Access Compliance Report

Public Rights-of-Way

Intersection ID: 42366	Main Street: CARDINALS_NEST_DR	Cross Street: HERON_GLEN_DR	Location: E
ADA ID: 817A7C18517B	Ramp Type: BlendTrans1	Initial Pass/Fail: Pass	Overall Compliance: No
		Severity Score: 10

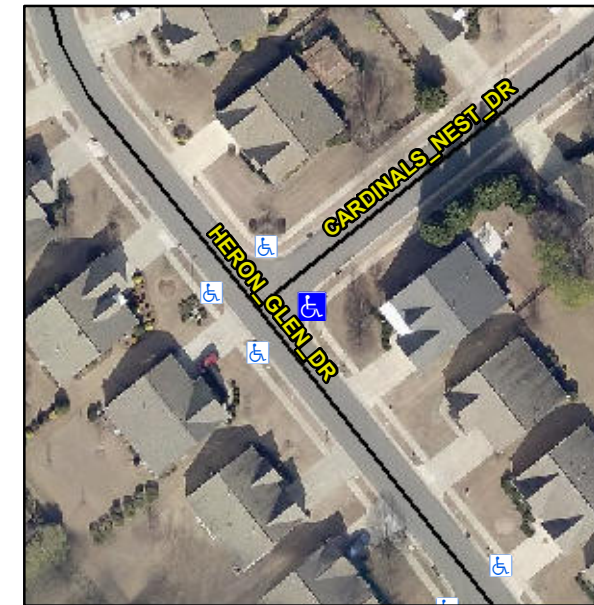
Not Found, R304.2.1, R304.2.2-Perp, R304.3.2-Para, R304.5.3, R305

N/A	Ramp inside XWalk1?	N/A	N/A	Ramp inside XWalk2?	N/A
	Road Slope (%)	4.2		Clear Space?	Yes
	Road X Slope (%)	0.8	N/A	Clear Space to XWalk (in)	N/A
Yes	Any Obstructions?	No	Yes	Storm Grate/Utility Hazard?	No
	Obstruction Type			Storm Grate/Utility Type	
		N/A			N/A
			Yes	Surface Condition? (G/P)	Good
			No	Curb Slope (%)	14.7

Remove & Replace Curb Ramp With Two New Directional Ramps or Equivalent.
